Groundwater Transfer Review Summary Form

Transfer/PA # T- 14104

Application: T-14104

Applicant Name: Avion Water Co. Inc

Hydrograph 2. Water level trends in observation wells adjacent to the Dyer Well 1 & 2 (DESC 58007 & DESC 62703).

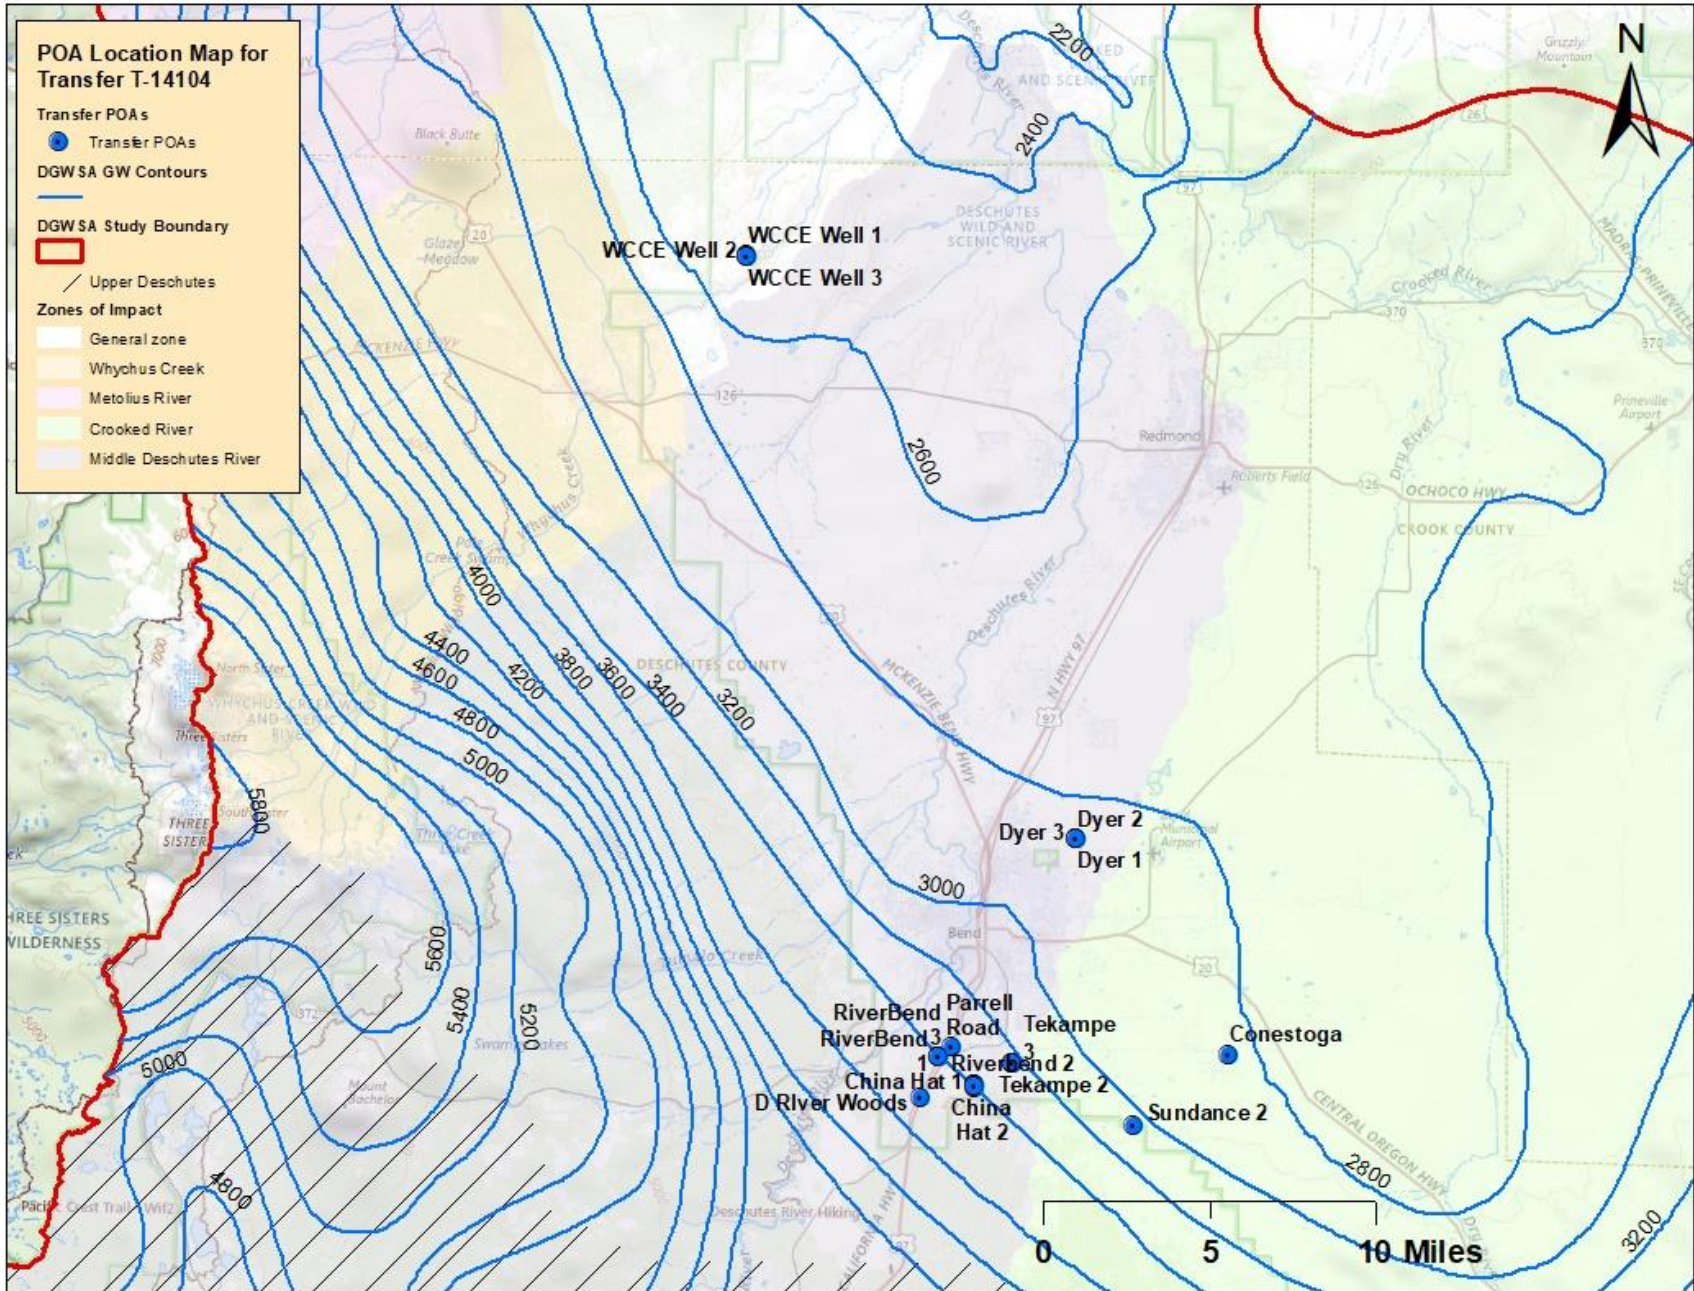
- Dyer Well 1 (DESC 58007) had a water level of 694 feet BLS (2730 ft AMSL) when it was drilled in the spring of 2007. There have been no other water levels submitted to OWRD for DESC 58007, but other wells in this part of the aquifer (DESC 58255, CROO 24, DESC 5045) have declined more than 25 feet since spring of 2007. CROO 24 has declined 27.95 feet from April 2007 to January 2026 (see Hydrograph 2). **Dyer Well 1 (DESC 58007) is assumed to have exceeded the 25-ft decline condition.**

Hydrograph 3. Water level trends in observation wells adjacent to the Whychus Canyon Creek Estates Area. Longer-term observation wells indicate that water levels have declined 30-50 feet since the well log-based reference levels.

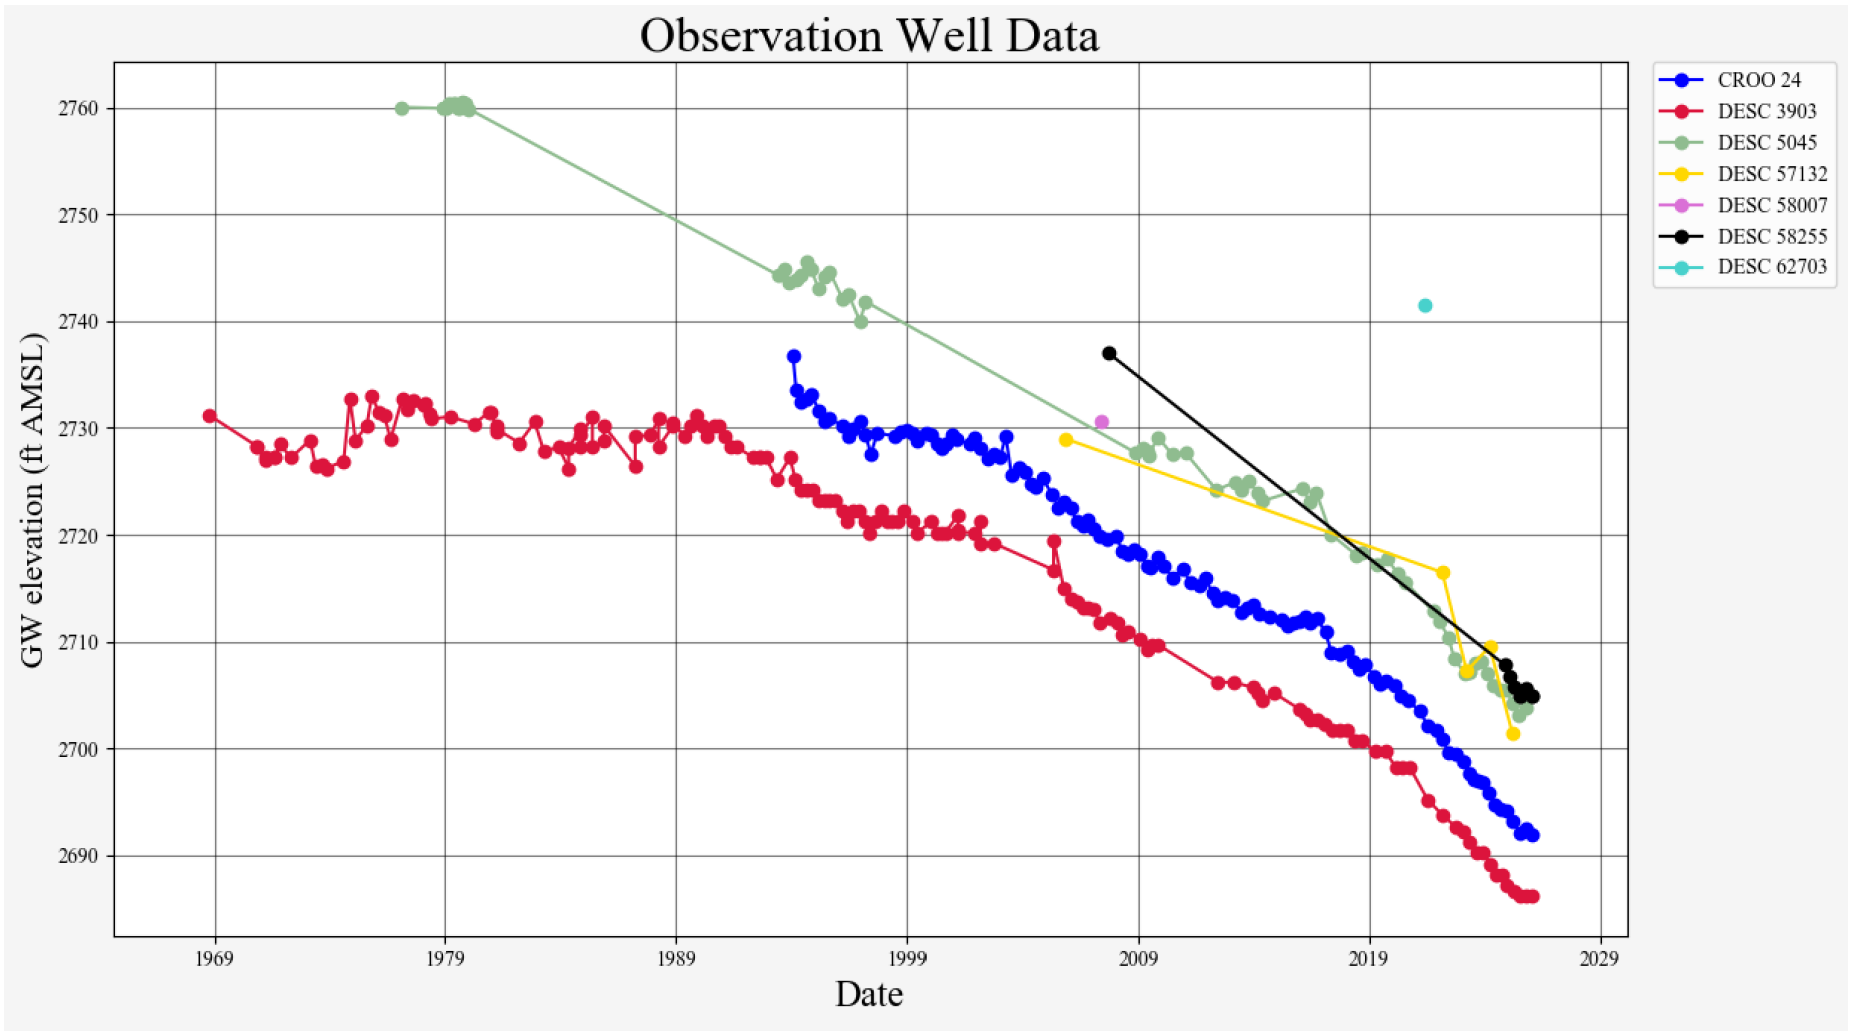
- WCCE APOAs (DESC 58167, DESC 53193, & DESC 53194) reference levels under the pertinent Water Level Measurement plan would be the water levels on their original well logs. This part of the aquifer has declined 30-50 feet since these wells have been drilled (see Hydrograph 3). **Wells DESC 58167, DESC 53193, & DESC 53194 are assumed to have exceeded the 25-ft decline condition.**

Hydrograph 4. Water level trends in observation wells adjacent to Sundance Well 1 (DESC 5725). Longer-term observation wells indicate that water levels have declined 15-20 feet since well log-based reference levels.

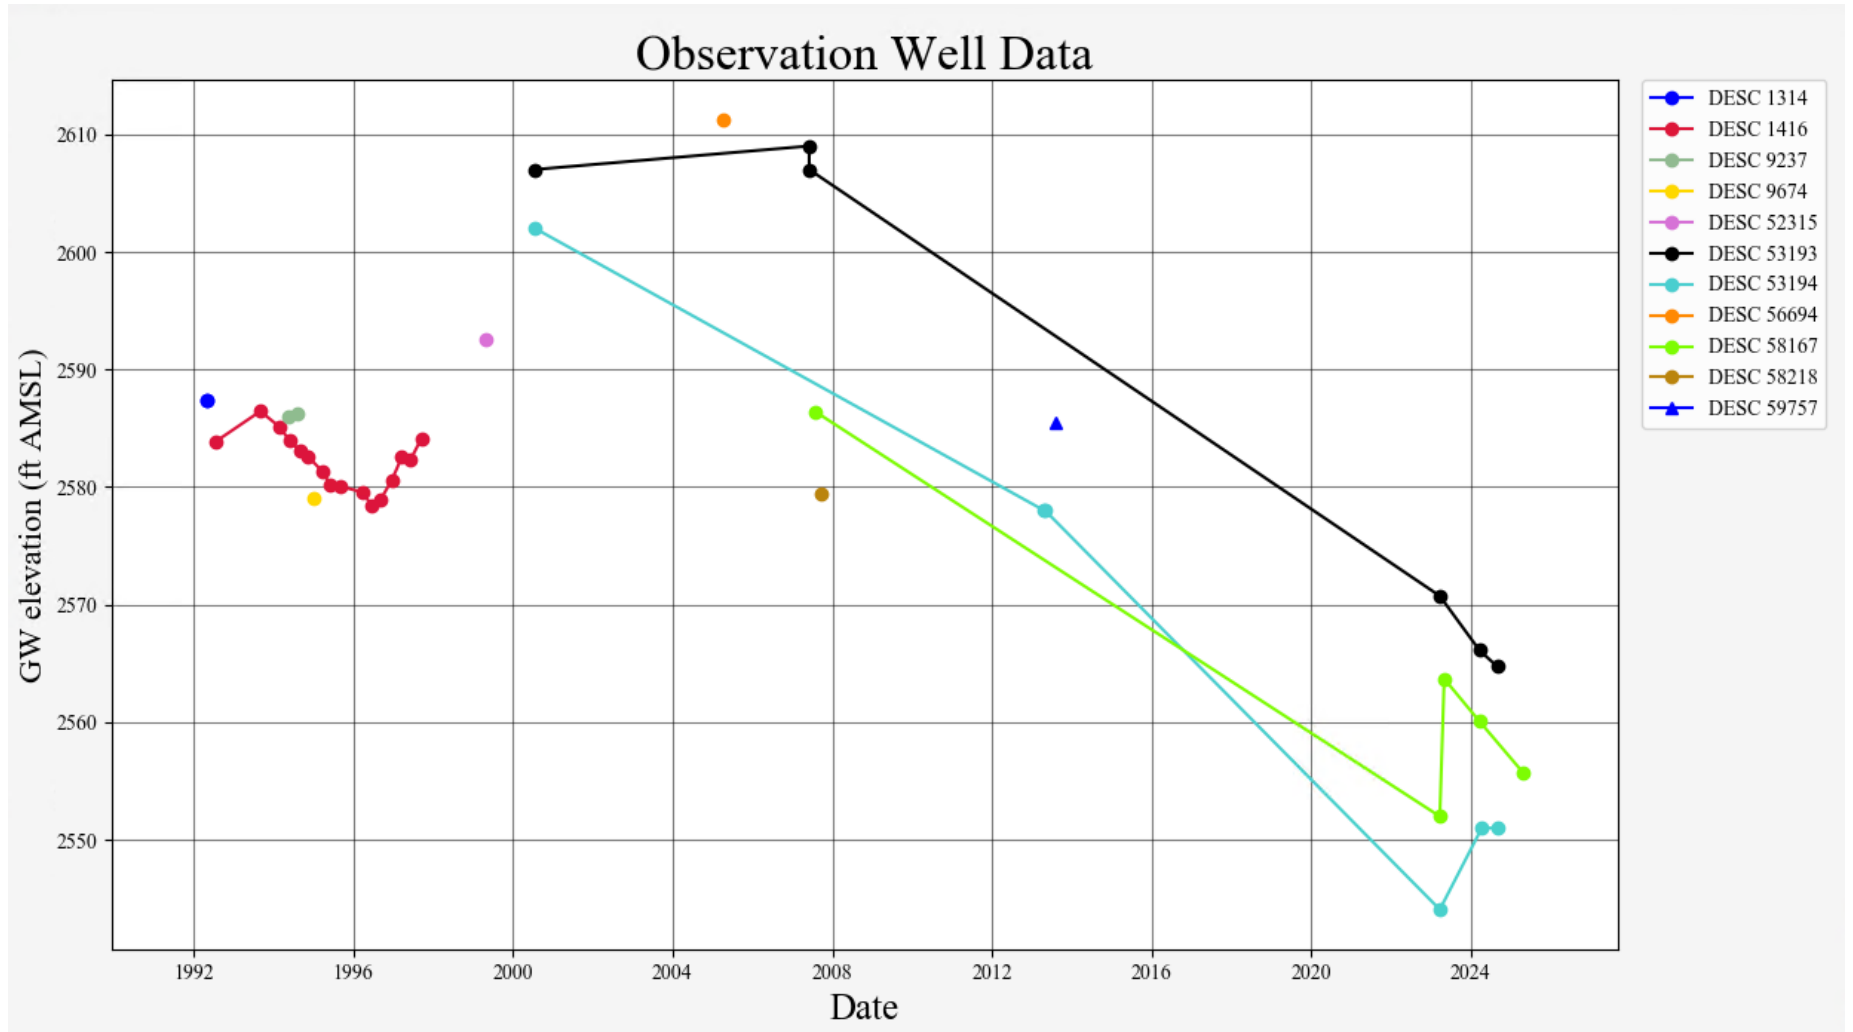
- Sundance Well 1 (DESC 5725) accesses a part of the aquifer that appears to have declined 15-20 feet (see Hydrograph 4). This well is assumed not to have exceeded the 25-ft decline condition.

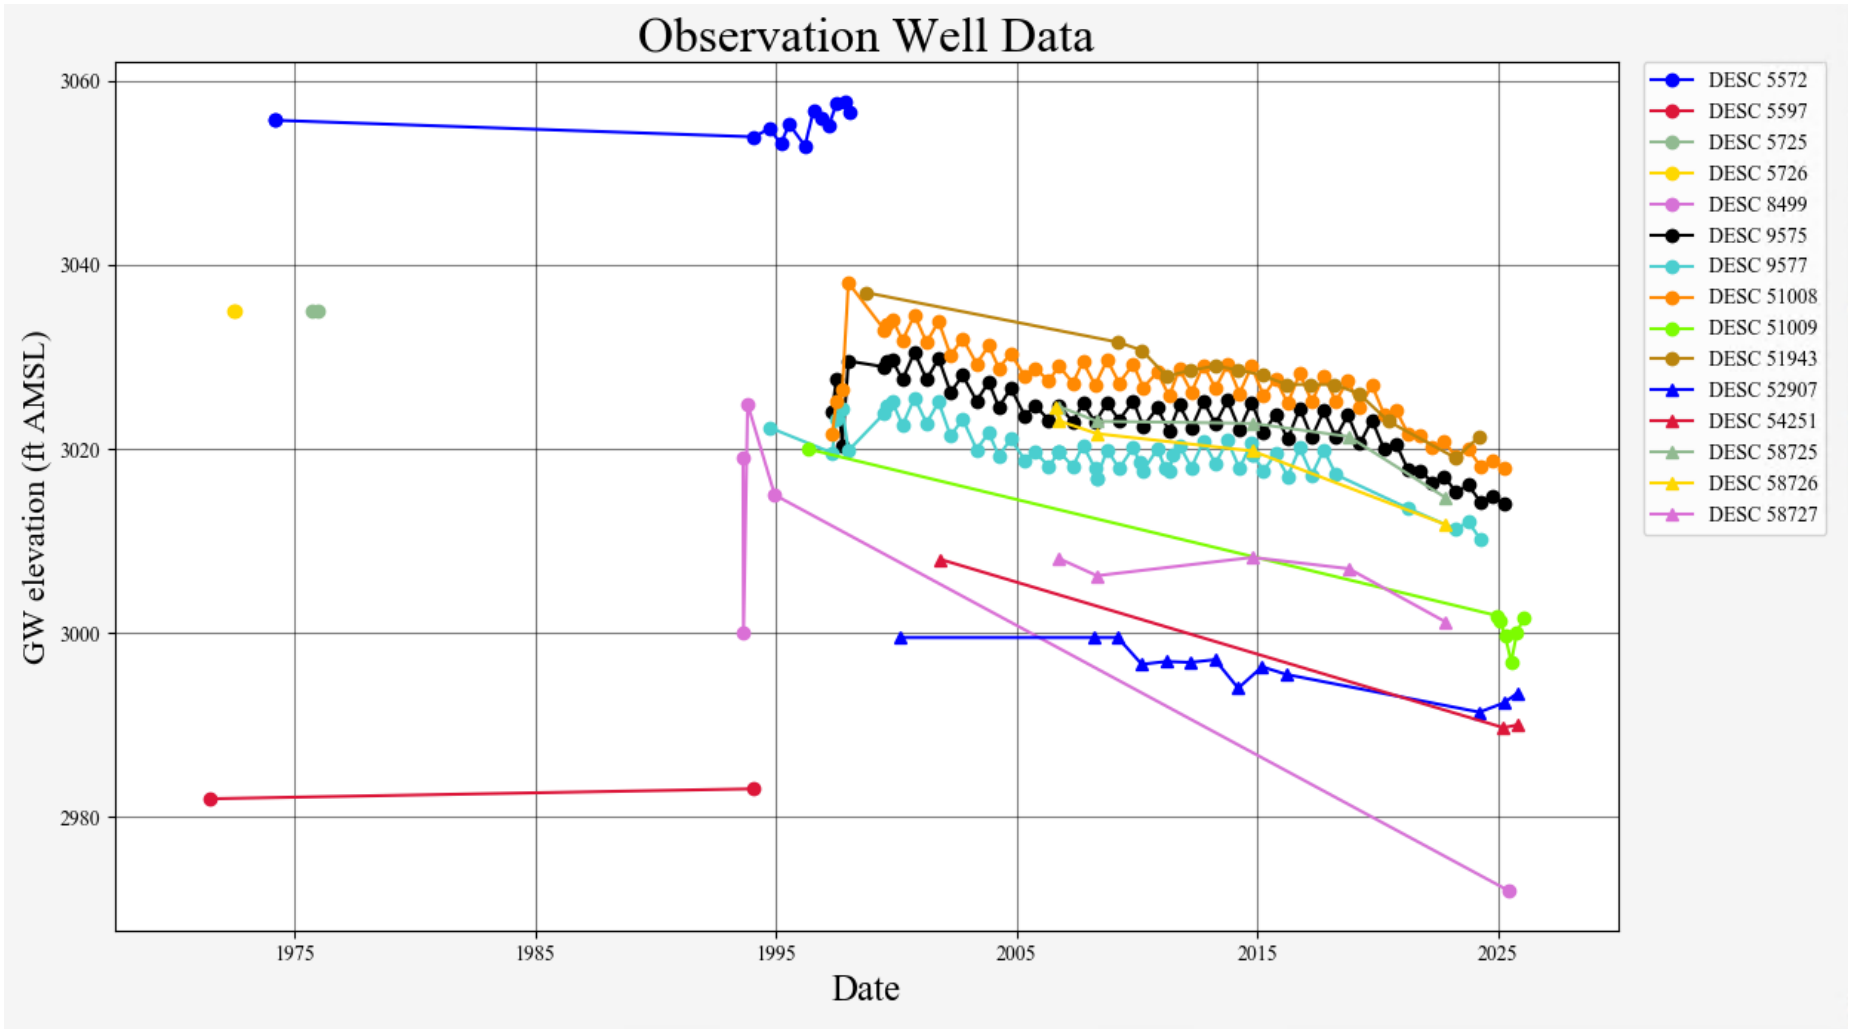
- The Conestoga Well (DESC 5722) is in a part of the aquifer that shows some stable water levels and some declines (see Hydrograph 5). There is not a preponderance of evidence that the well has exceeded the 25-ft decline condition.

Hydrograph 6. Water level trends from observation wells adjacent to the Deschutes River Woods Well (DESC 55124). Adjacent observation wells indicate that this part of the aquifer has declined 10-20 feet since 2003.

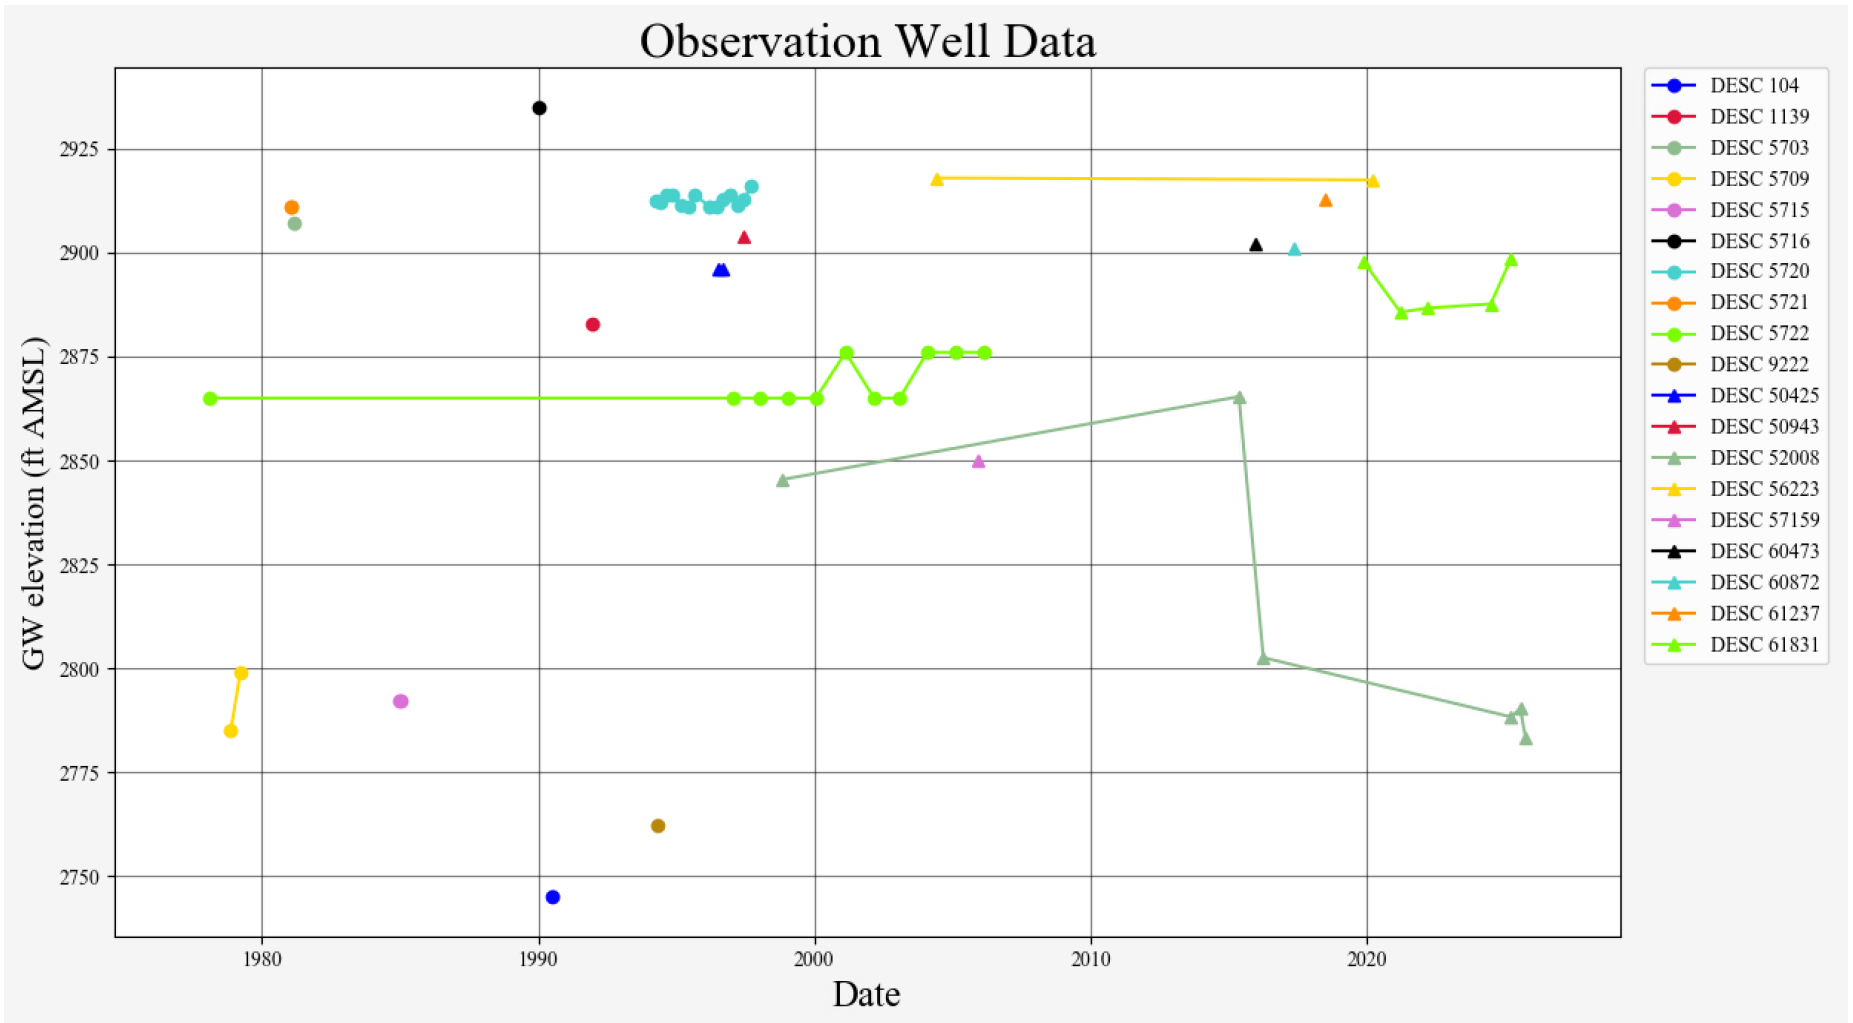
- The Deschutes River Woods Well (DESC 55124) accesses a part of the aquifer that appears to have declined 10-20 feet since 2003 (see Hydrograph 6). This well does not appear to have exceeded the 25-ft decline condition.
